CITY OF VAUGHAN

EXTRACT FROM COUNCIL MEETING MINUTES OF NOVEMBER 19, 2013

**OFFICIAL PLAN AMENDMENT FILE OP.12.003
ZONING BY-LAW AMENDMENT FILE Z.12.008
JOHN DUCA
WARD 2 - VICINITY OF REGIONAL ROAD 7 AND KIPLING AVENUE**

1. THAT Official Plan Amendment File OP.13.003 and Zoning By-law Amendment File Z.13.008 (John Duca) BE REFUSED.
2. THAT City Staff and external consultants be directed to attend the Ontario Municipal Board in support of the refusal.

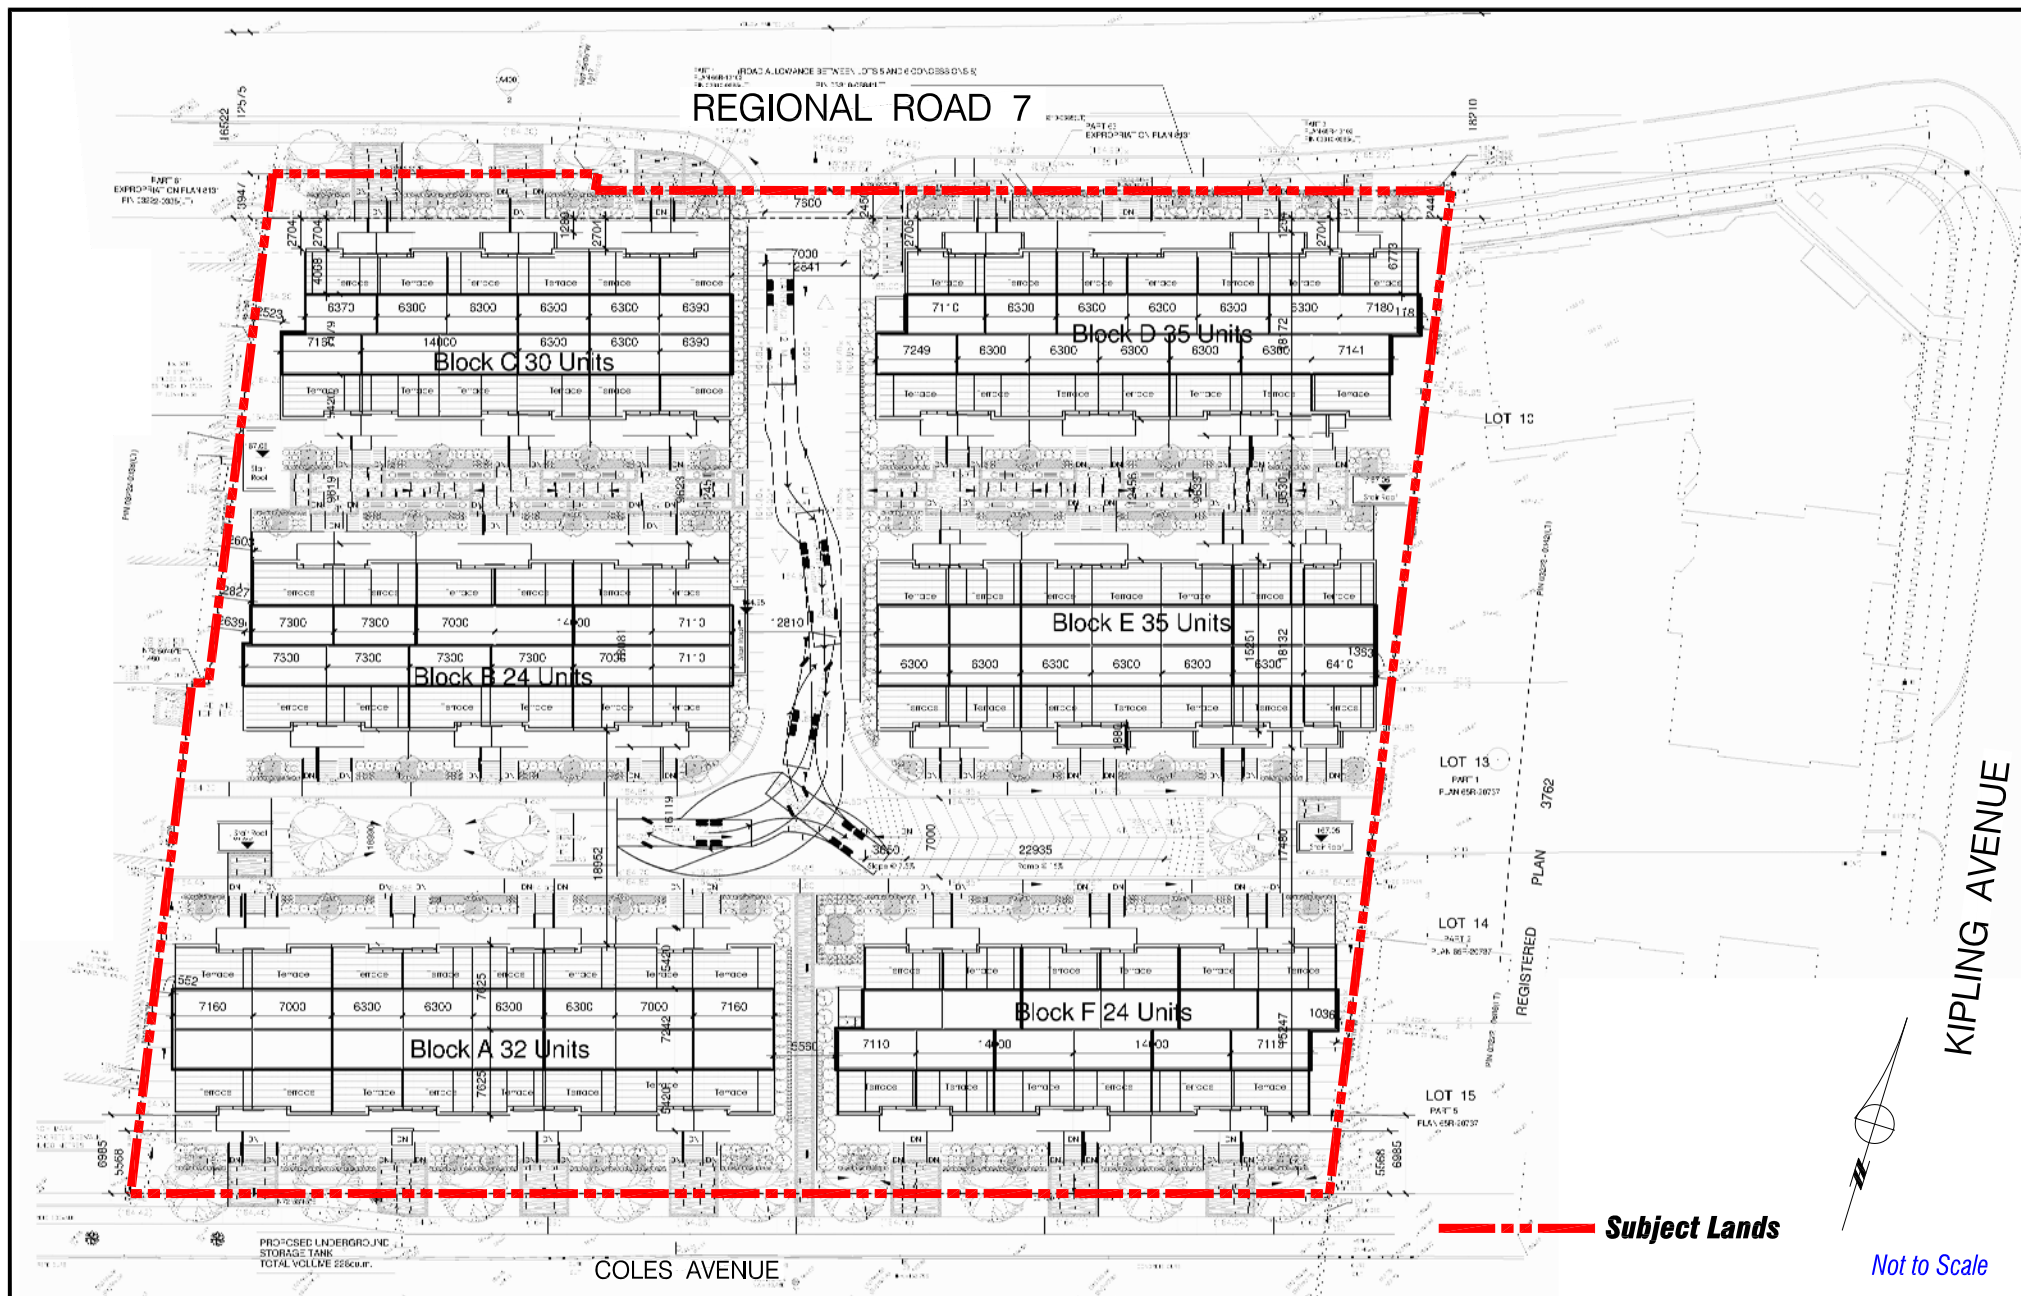
- the plans do not incorporate the road widening (22.5m from the centreline of Regional Road 7) and sufficient building setback to avoid encroachments (e.g. stairs, opening doors, etc.) into the Regional right-a-way, which will impact the location of Blocks “C” and “D” on the proposed site plan (Attachment #3), and potentially the balance of the proposed site plan;

- the proposed plan does not protect for a future consolidated driveway access to accommodate future development on the lands to the west (5317 Regional Road 7), which can only be achieved either by a driveway (and any required easements) located at the west limit of the subject lands or alternatively and east/west driveway in the northerly portion of the site connecting to the lands to the west. The provision of either driveway will impact the proposed site plan shown on Attachment #3.

In order to address these technical comments, the proposed site plan shown on Attachment #3 and all of the related plans and supporting documents must be modified. To date, the Owner has failed to comprehensively respond to any of these technical comments and considerations. As a result, the proposed plan does not address fundamental technical requirements. The plans and supporting documents must be amended to address these issues, formally submitted as a complete application package and the appropriate City Departments and commenting agencies, afforded adequate time to review an amended proposal.

- Excessive car and truck penetration into the site must be minimized by relocating the proposed “T” driveway intersection closer to Regional Road 7. Moving the “T” intersection further north will provide for a more prominent centrally located amenity area within the development.

Typical Stacked Townhouse Layouts as Submitted with Applications

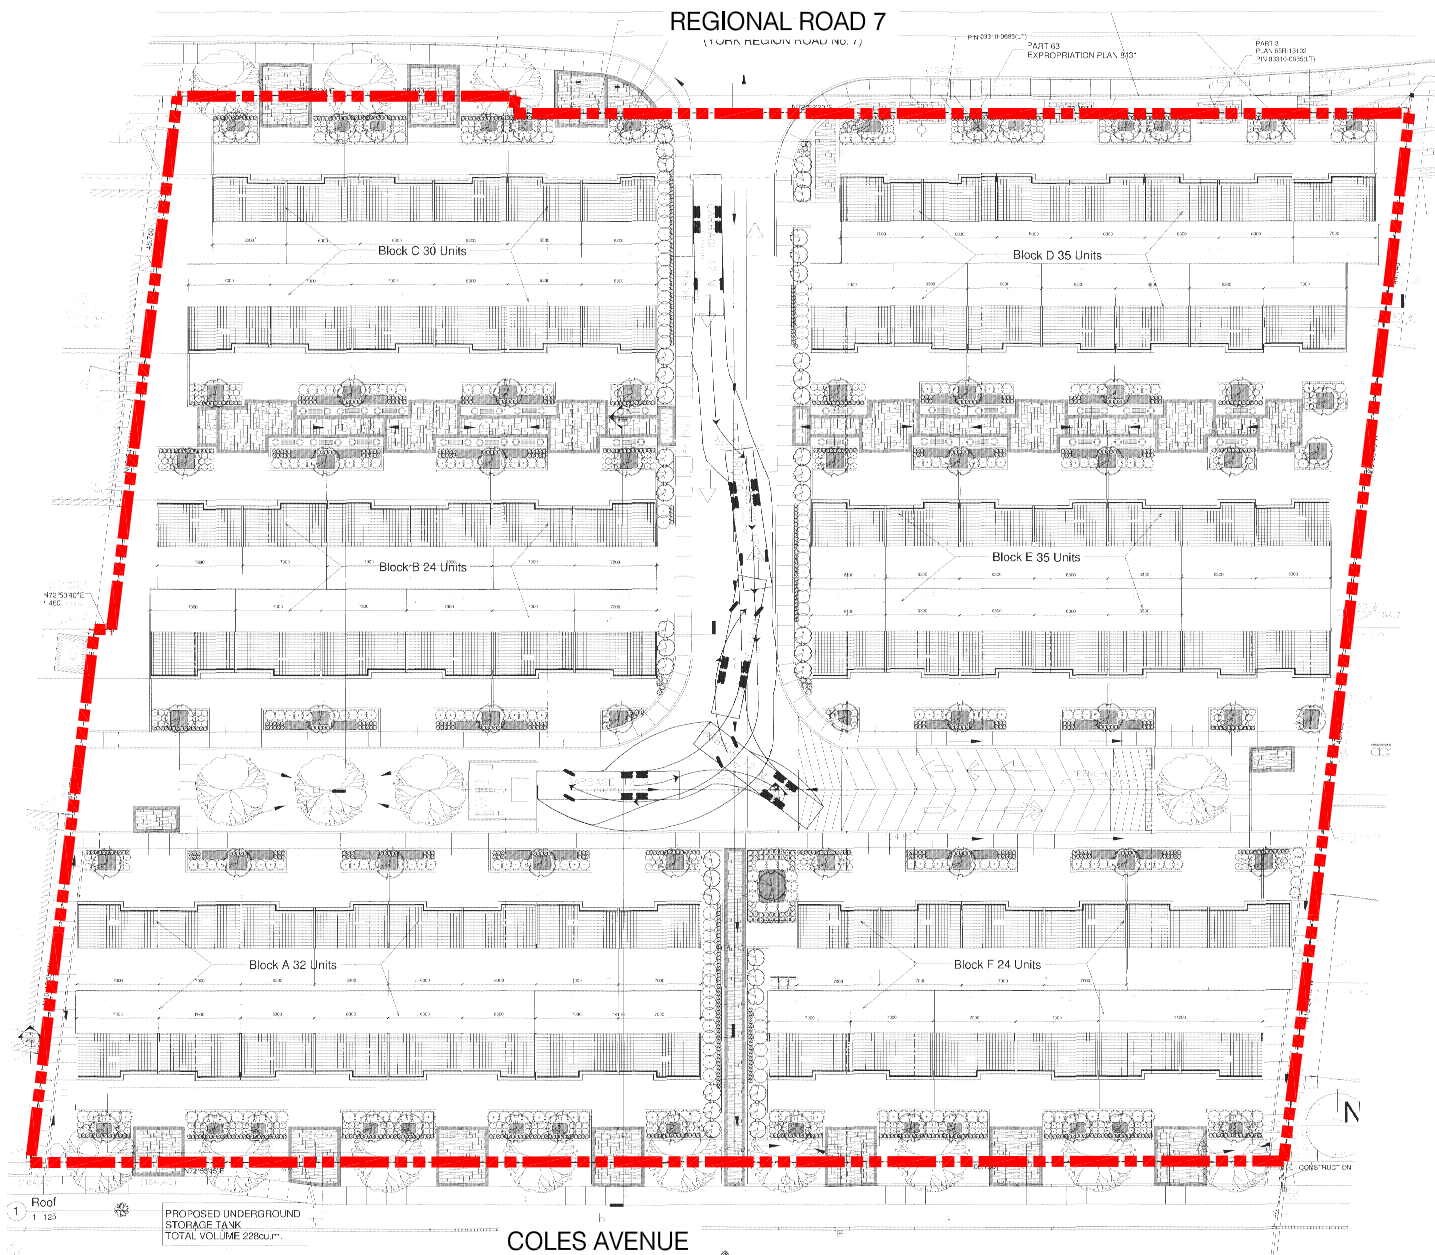
The applicant is requesting an exception to Zoning By-law 1-88 to permit a maximum building height of 12.8 m and has suggested that the proposal be considered a 3-storey building, which would exclude the top level as it is proposed to be devoted to a mechanical room. Zoning By-law 1-88 and the Ontario Building Code provide exemptions for a mechanical rooms being considered as a storey. The review of the elevation plans, floor layouts and building sections by the Building Standards Department has resulted in the determination that the proposed stacked townhouse units are four storeys in height for the purposes of Zoning By-law 1-88. The area devoted to the mechanical uses is 2.45 m in height, extends across the full width of each block, includes ample area to provide living space, and leads to terrace areas, as shown on Attachment #7.

The Building Standards Department has also advised that the area below grade is considered a basement and therefore falls outside the definition of a storey. However, the Ontario Building Code and Zoning By-law 1-88 considers storeys based on the average grade around the entire building. The elevation and building section plans submitted in support of the application illustrate that more than half of the basement level floor space is below grade. Detailed grading information is required to determine if the basement level is a storey as defined by Zoning By-law 1-88, and the Ontario Building Code.

The plans submitted in support of the proposal indicate a Floor Space Index of 1.76, consistent with the density policy of OPA #661, but underutilizing the land. The plans also illustrate a minimum of 4-storeys of living space that includes a basement storey for habitable space, three additional levels for residential living space, with another storey for roof-top mechanical equipment which is 2.45 m high, extends across the full width of each building and include sliding doors to roof-top terraces as shown on Attachments #5, #6 and #7. As such, in certain areas, the proposed stacked townhouse units will have the appearance of being 4.5 to 5-storeys in height.
